LXT971A/972A PHY Transceivers

Specification Update

May 2002

Order Number: **249354-007**

Figure 1. Ordering Information - Sample

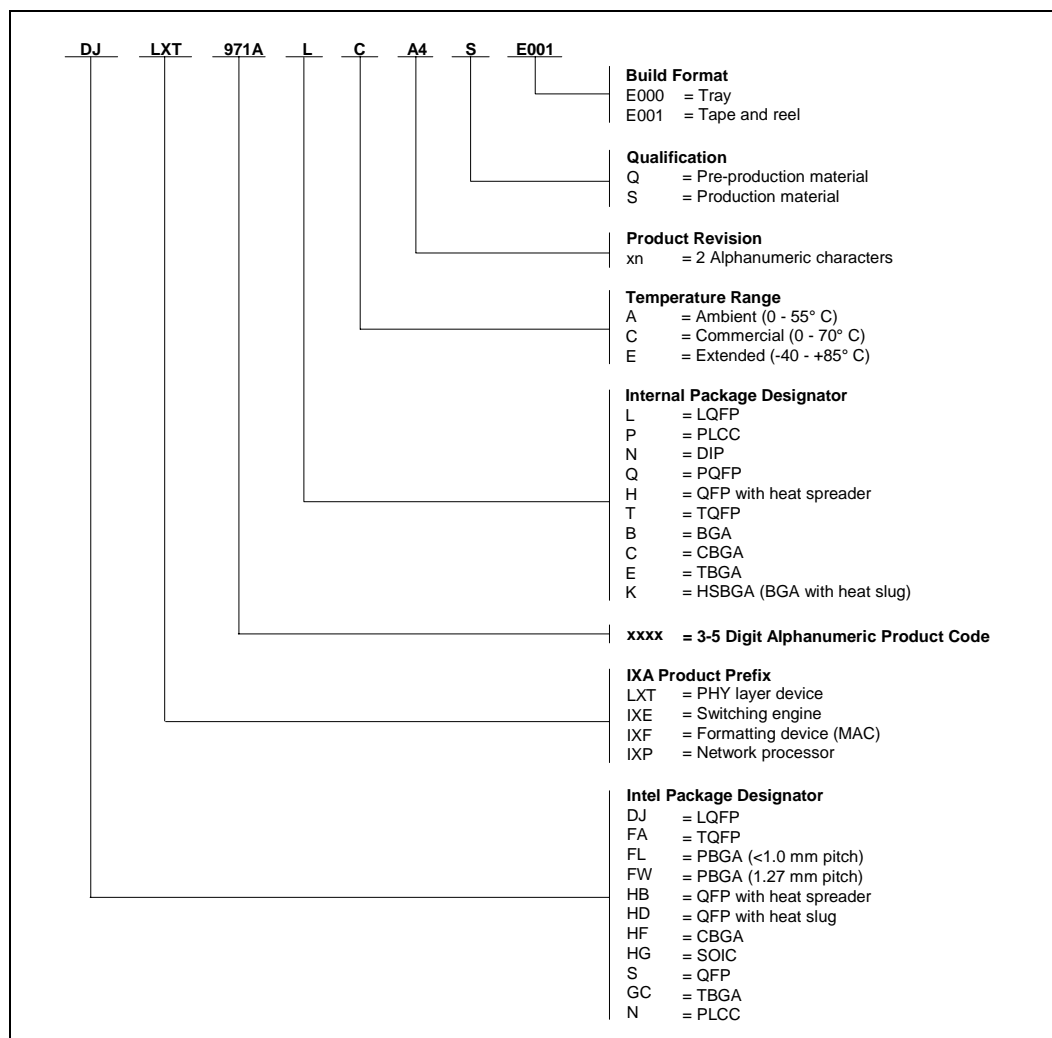
Documentation Changes

Table 3. Product Information
